Product / Process Change Notification (PCN)	
<input type="checkbox"/> Major Change <input checked="" type="checkbox"/> Minor Change	
PCN Number: PCN_IndHCF_IndHCFT_20241115 Affected Series: WE-HCF, WE-HCFT Affected Order Codes: See table 1 for list of affected order codes PCN Date: 2024-08-15 (YYYY-MM-DD) Effective Date: 2024-11-15 (YYYY-MM-DD)	Change Category: <input type="checkbox"/> Equipment/Location <input checked="" type="checkbox"/> General Data <input type="checkbox"/> Material <input type="checkbox"/> Process <input type="checkbox"/> Product Design <input checked="" type="checkbox"/> Shipping / Packaging <input type="checkbox"/> Supplier <input type="checkbox"/> Software
Contact: Product Management Phone: +49 (0) 7942 - 945 5001 Fax: +49 (0) 7942 - 945 5179 E-Mail: pcn.eisos@we-online.com	Datasheet Change: <input checked="" type="checkbox"/> Yes <input type="checkbox"/> No Attachment: <input type="checkbox"/> Yes <input checked="" type="checkbox"/> No

Description of Change: <u>Alteration (1):</u> To meet current customer demands, Würth Elektronik eiSos will include the information regarding operating voltage in the datasheets based on internal test procedure. This is an i

Table 5: Packaging changes of affected order codes.

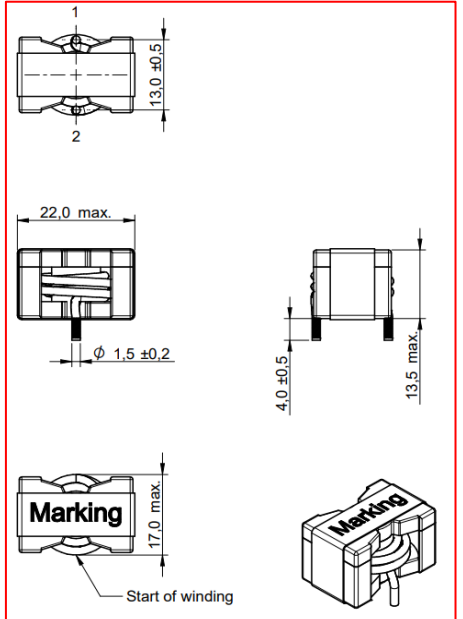
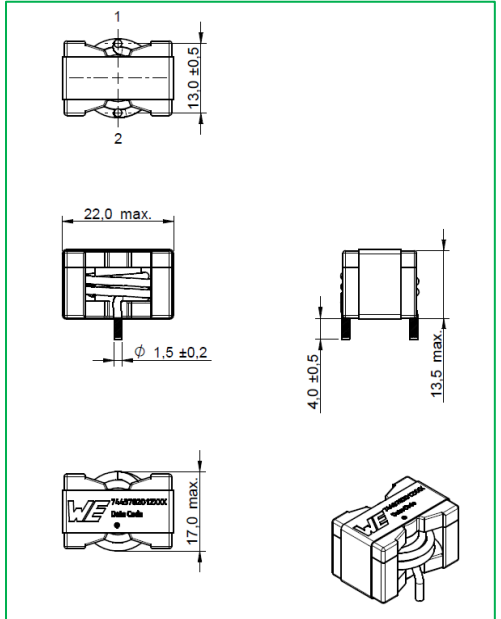
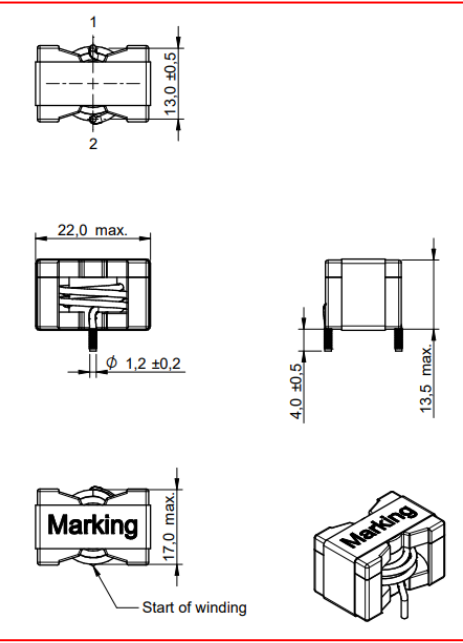
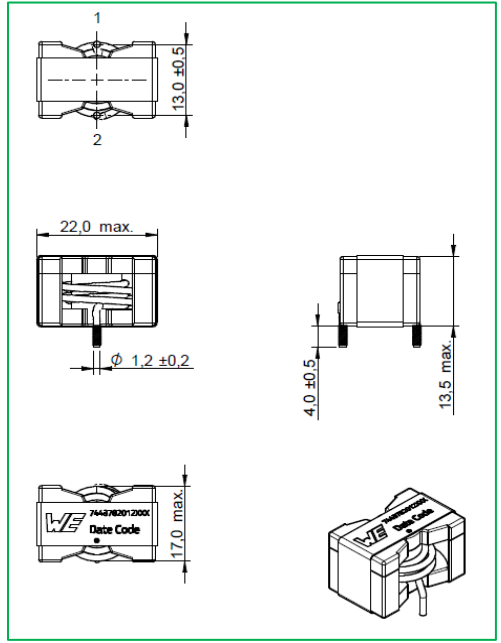
To reduce the amount of packaging waste in the product series WE-HCF and WE-HCFT, with sizes and order codes indicated in Table 4, the inner boxes will be omitted. No plastic filler will be used, and every reel will be stacked and separated by paperboard. The outer box dimension will be updated accordingly. Additional details of the changes can be found in Table 5. The modification is only valid for products with Tape and Reel (T&R) packaging and lot numbers started with '321', being not applicable when tray packaging is used.
